# MODIFICATIONS TO

# CONTRACT EROSION PREVENTION

# SEDIMENT CONTROL (EPSC) PLAN

# CORINTH BRO 1447(29)

Former Log Landing
220' +/-
95' +/-
Proposed Staging, Office Trailer and Waste Stockpile Area
overhead E & T
Existing Drive
N
1" = 25'
VT Route 25

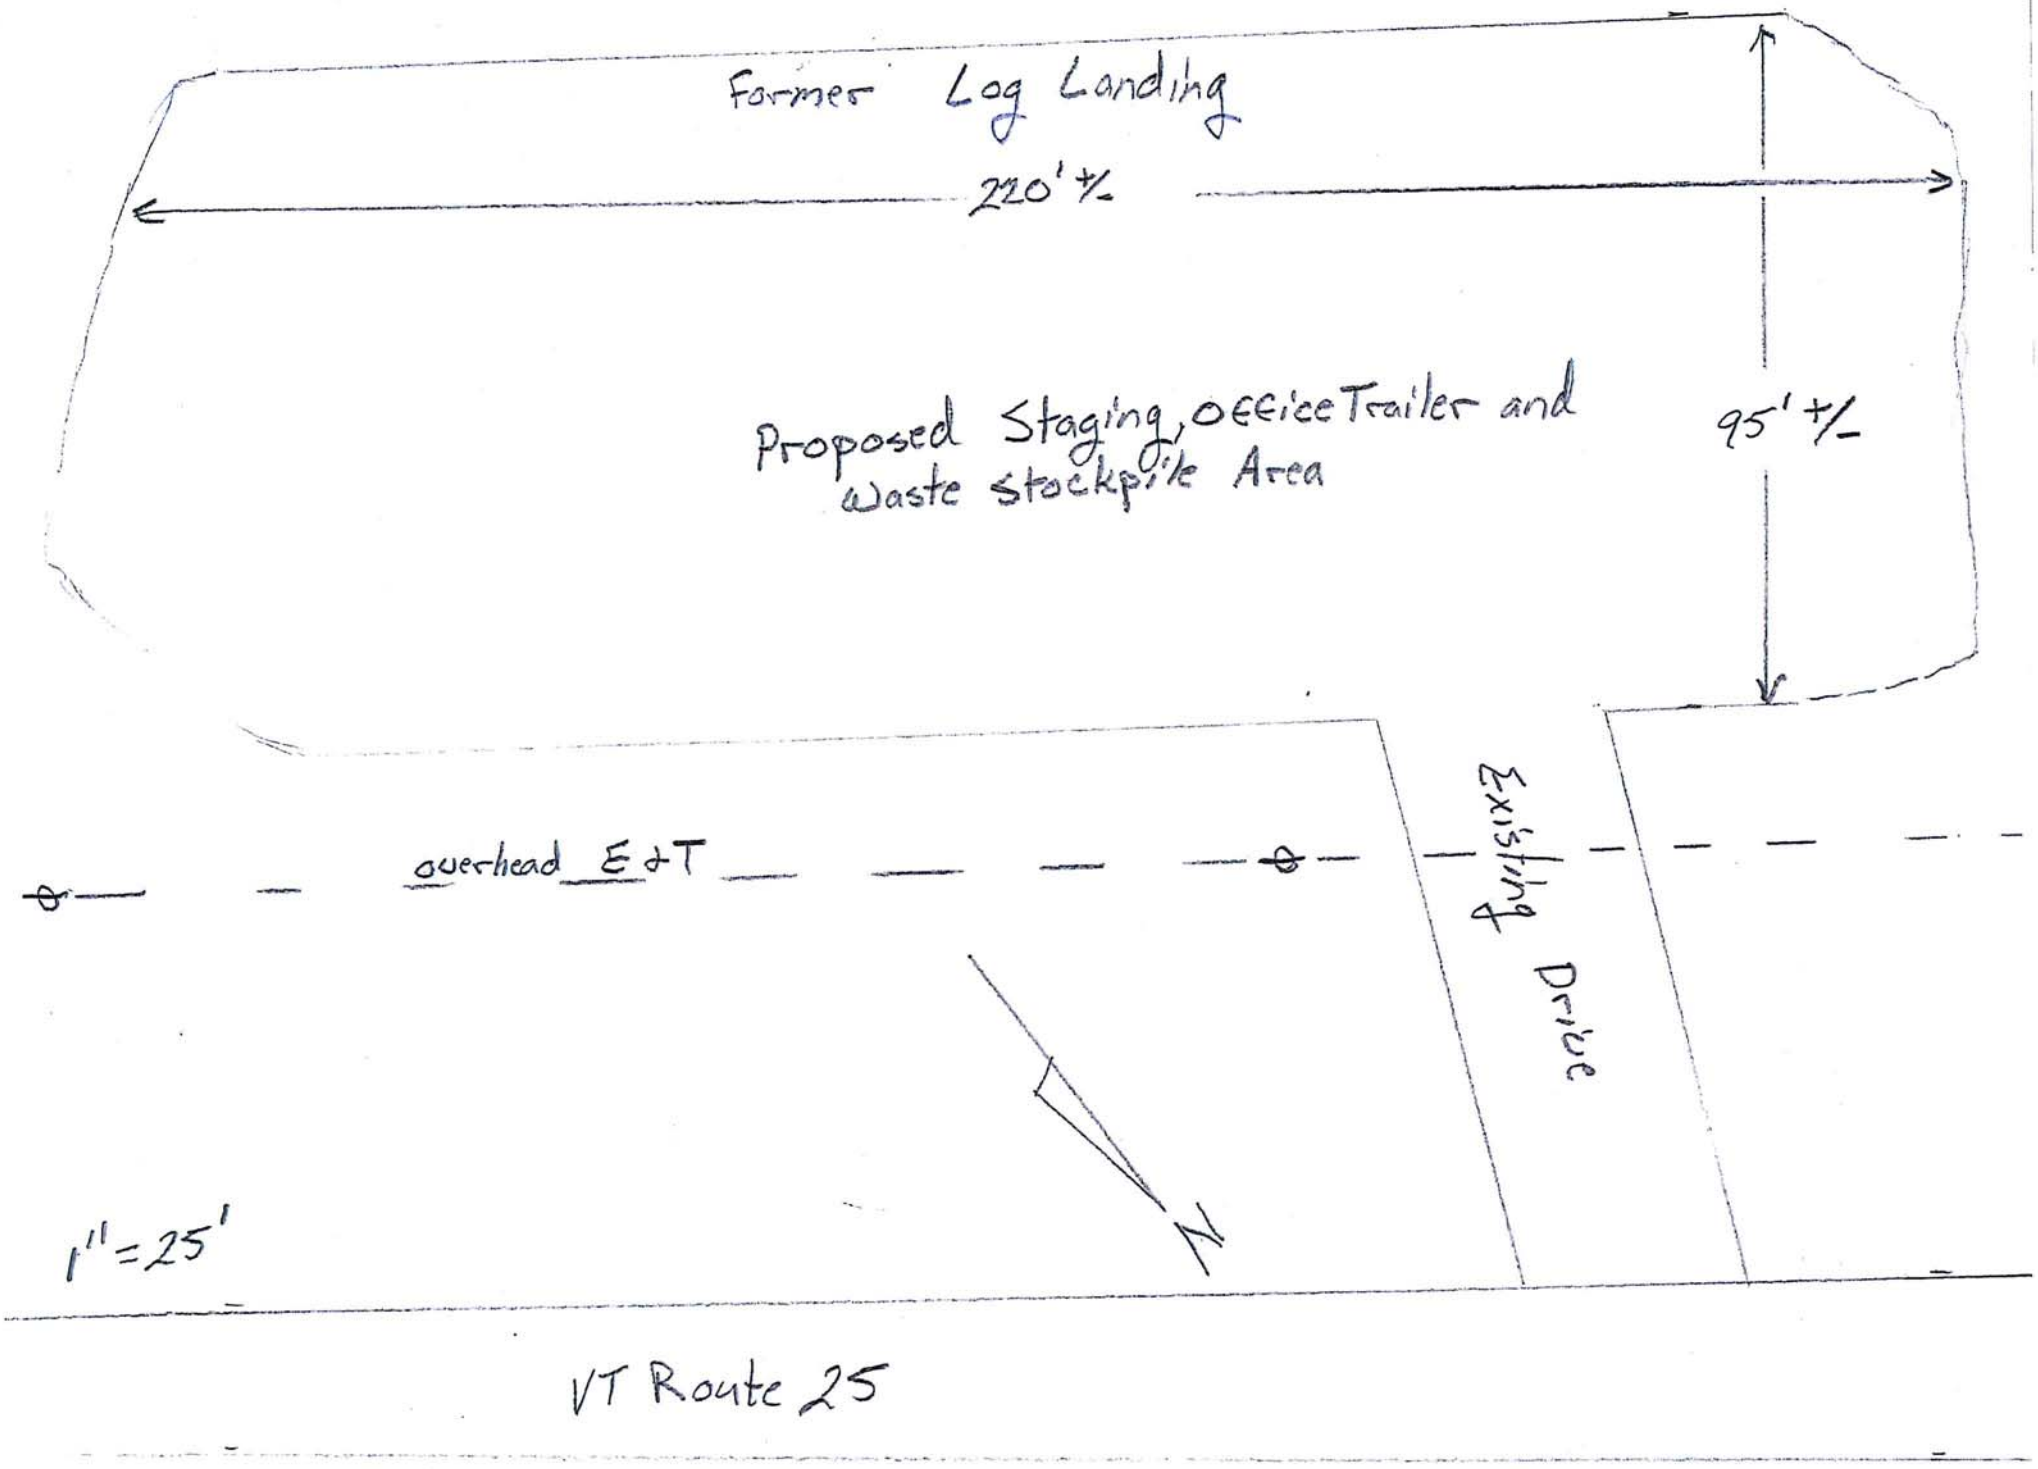
Add. – 1.1.1: The Project will also include a field office site, waste and borrow. *Site staging will be within the limits of the work area limits of disturbance and at the field office site. The field office site is located approximately 0.7 miles south of the project on VT Highway 25. The site is a previously disturbed log landing.*

1.2.1 Topography:
Add – 1.2.1.1: The proposed staging area includes slopes approximately 2%. Site drainage is towards highway 25 and is approximately 500 feet from the Waits River.

1.2.3 Vegetation:
Add – 1.2.2.1: The proposed access and staging includes exposed sand and gravel areas.

Area of Disturbance at the site is not expected to change from the design plans. Disturbance will include approximately 20,000SF (0.46 acres), the staging area will include an additional 21,000SF (0.47 acres) but the entire staging area will not be disturbed earth, disturbance will include travel areas and stockpile areas.

PHASE I EROSION CONTROL PLAN - FALL 2014

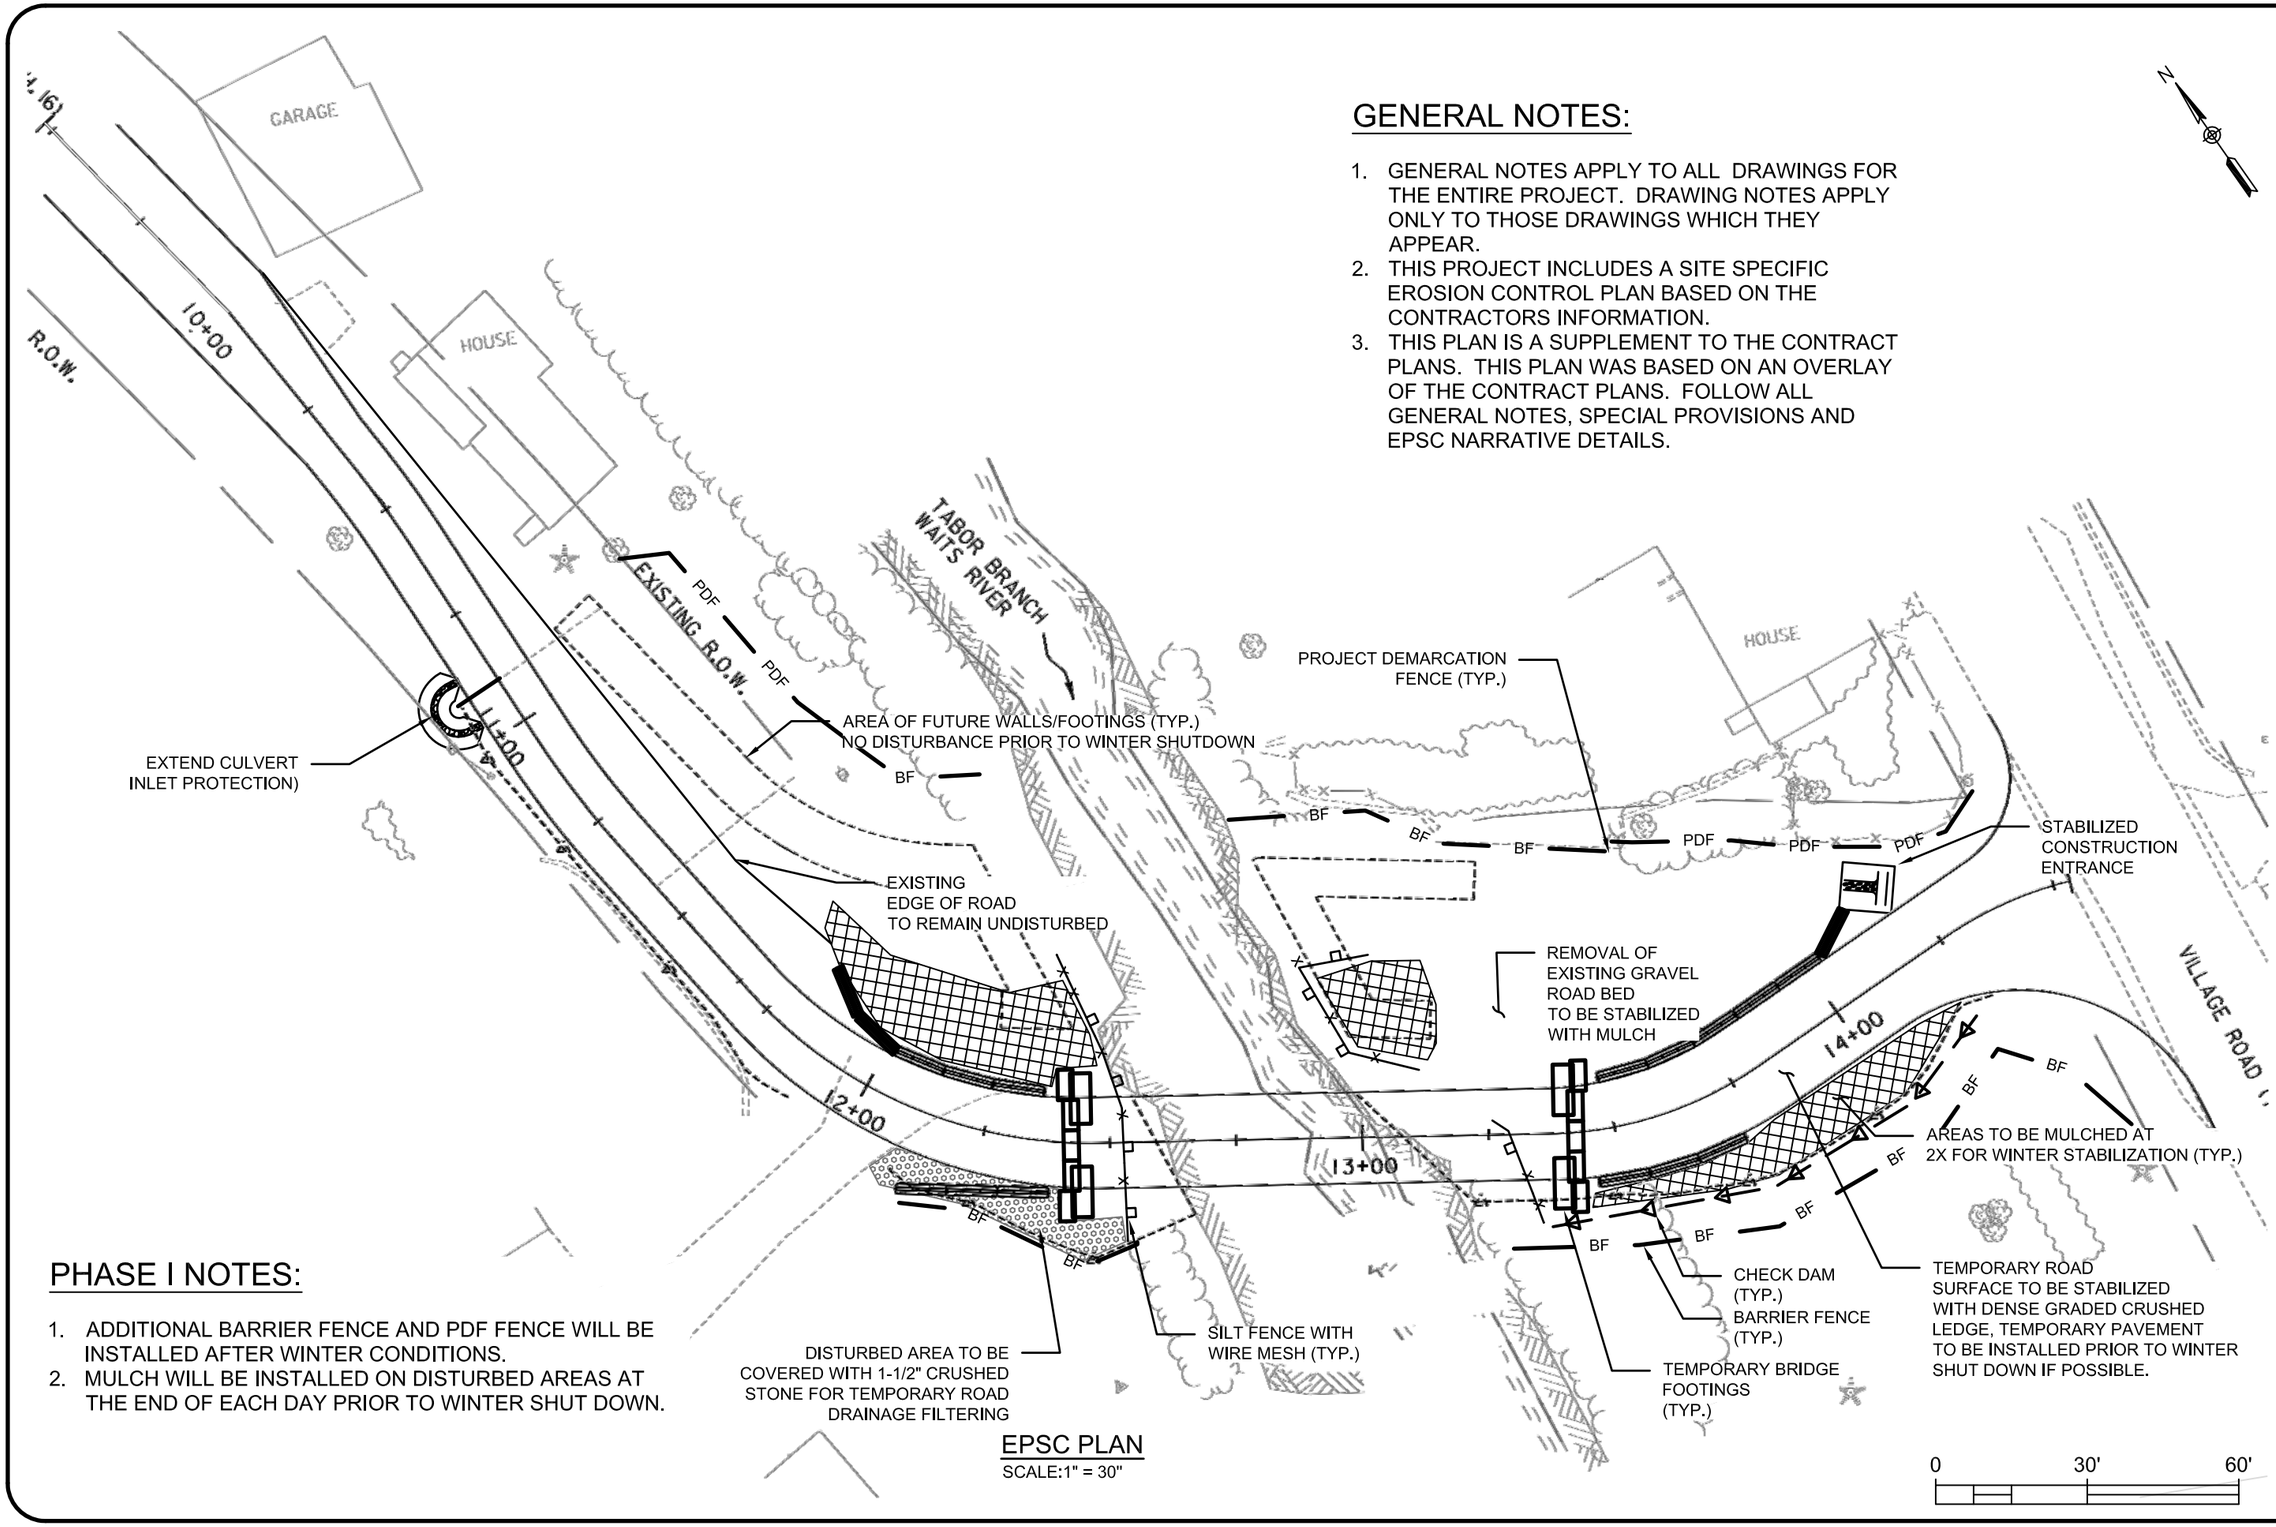
1.5.1.2. Detour Construction (Phase 1).

The detour construction will occur prior to winter shut down. The temporary bridge installation will require erosion stone, a temporary culvert and silt fence installation since vegetation is not expected to establish during winter conditions.

After the bridge erection, the detour approaches will be constructed. The approaches will remain at approximately the same elevation as the existing highway so the excavation plan shown on the contract plans will not be required. Only temporary ditching will be used to channelize flow as shown on the EPSC plan. The ditch will be stabilized with erosion matting and stone check dams.

PHASE II EROSION CONTROL PLAN
SITE SPECIFIC EROSION CONTROL PLAN

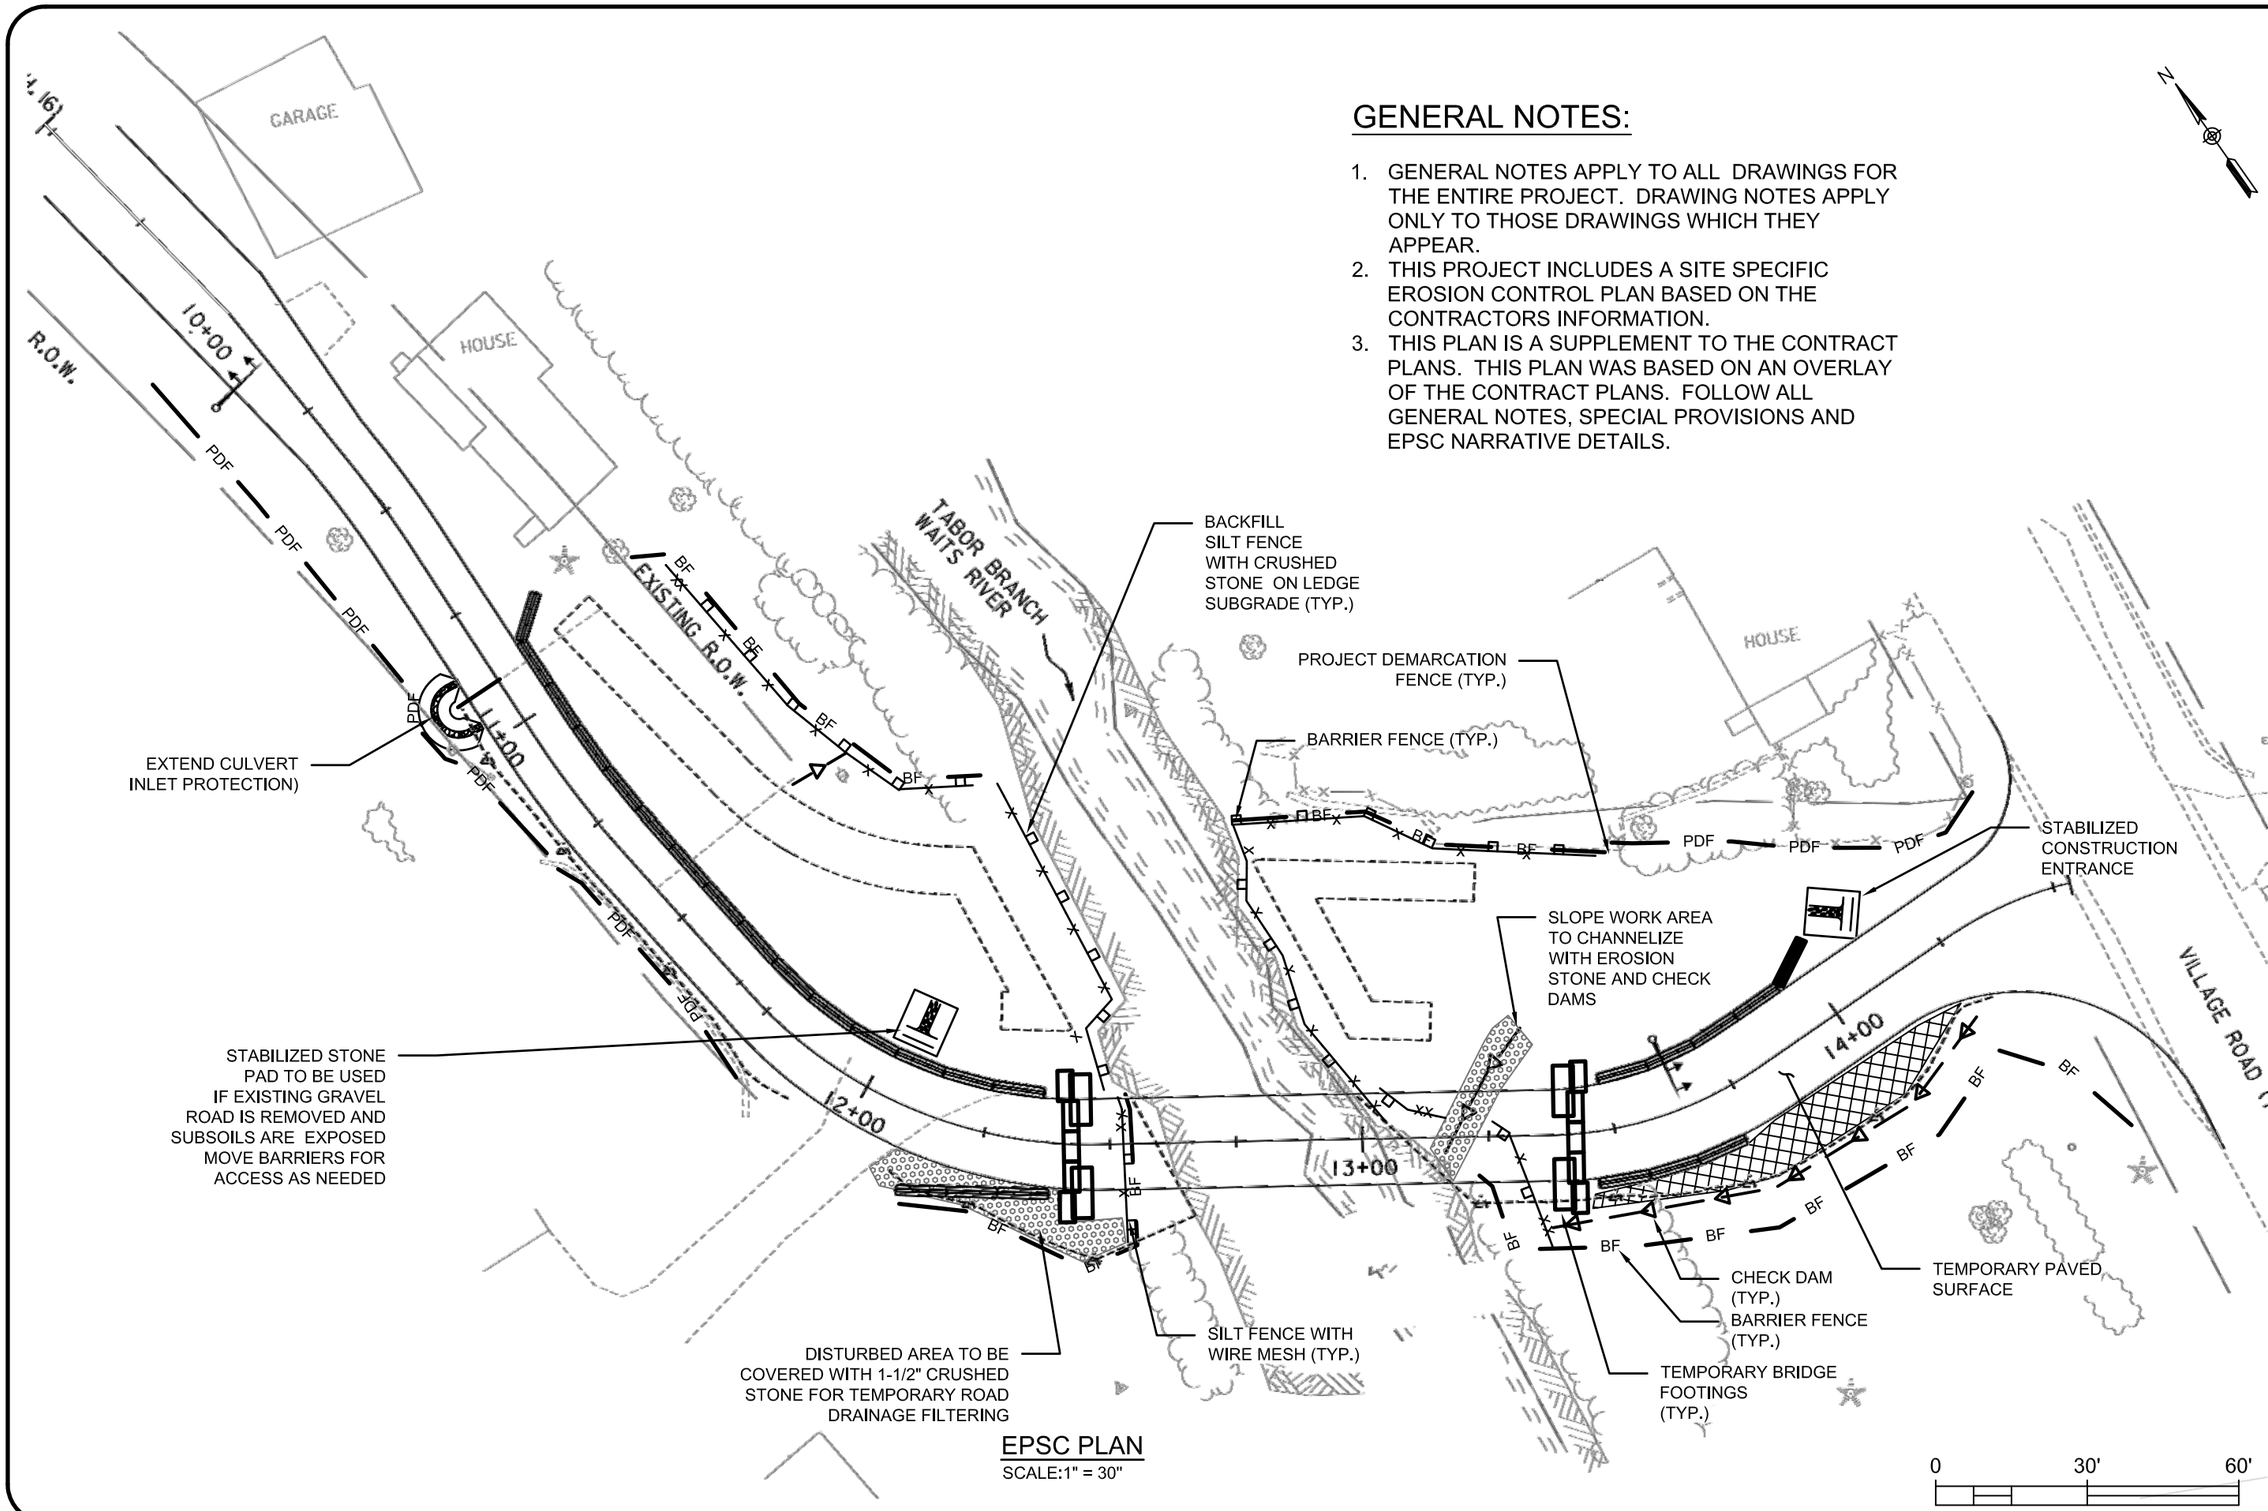
1.5.1.3. Abutment Construction (Phase 2)

Abutment construction will occur during the spring of 2015. Abutment construction will include excavation to the existing riverbed ledge. Installation of sediment barriers along this work zone will require backfill with crushed stone.
